National Highways Planning Response (NHPR 25-01) Formal Recommendation to an Application for Planning Permission

Council's Reference: PL/2023/09142

Location: Land at Junction 16 (M4), Swindon

National Highways Ref: NH/23/03529

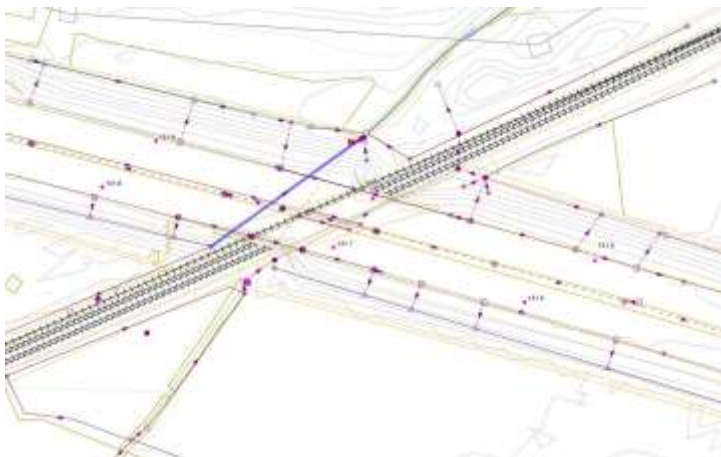
It is also noted that the proposal to install a new roundabout on the B4005 will impact the existing surface water drainage between the M4 J16 Spittleborough Roundabout and Hay Lane, to which National Highways currently has a lease title. This is indicated within the Conceptual Surface Water Drainage Strategy drawing 107846-PEF-ZZ-XX-DR-CD-0504. Any changes to the B4005 surface water drainage may have an impact on National Highways downstream M4 1200Ø Culvert at MP131.7+50m as indicated from our asset records below.

This will therefore need to be evidenced and addressed as part of the detailed drainage design for the development and associated access proposals. However, we

consider that this matter can likewise be addressed by a suitable pre-commencement planning condition to secure the submission of a detailed drainage design for our review and acceptance in respect of the SRN impacts.

4. Prior to the commencement of development, a detailed design for the treatment of surface water drainage shall be submitted to and approved in writing by the local planning authority (in consultation with the strategic highway authority). No surface water shall be permitted to run off from the development on to the strategic road network or into any drainage system connected to the strategic road network. No drainage connections from any part of the development shall be made to any strategic road network drainage systems. Surface water drainage measures shall be implemented in accordance with the agreed design prior to the development being brought into use and maintained as such thereafter.
